PRODUCT CHANGE NOTIFICATION (PCN)

A-MCSP-80005/Y MODULAR CABLE

PCN 20220425_A-MCSP-80005/Y

A-MCSP-80005/Y		OLD VERSION	A-MCSP-80005/Y		NEW VERSION
Apprearence			Apprearence

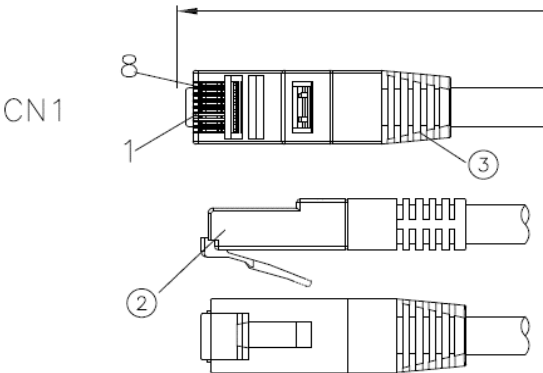
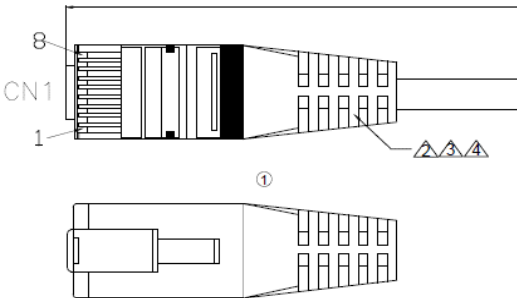
BOM			BOM		
③	Molding PVC	2	Molding PVC 45P		
②	RJ45 CONN	2	RJ45 8P8C,Two Fork gold plated contacts 3u" gold		
①	CABLE	1	SFTP(26AWG*x1PR)*4+AB,PVC OD:5.3±0.3mm		
NO.	NAME.	Q'TY	SPECIFICATION		
FOR DETAIL, PLEASE TAKE ATTACHED NEW DRAWING: FOR REFERENCE

①	④	AL-Foil	2	Double-sided conductive aluminum foil
①	③	Molding PVC	2	Molding PVC 65P
①	②	RJ45 CONN	2	RJ45 8P8C,Two Fork gold plated contacts 3u" gold Shielded
①	①	CABLE	1	SF/UTP(26AWG*x1PR)*4+AB(AL-MY),PVC OD:5.3±0.3mm
NO.	NAME.	Q'TY	SPECIFICATION	
FOR DETAIL, PLEASE TAKE ATTACHED NEW DRAWING: FOR REFERENCE
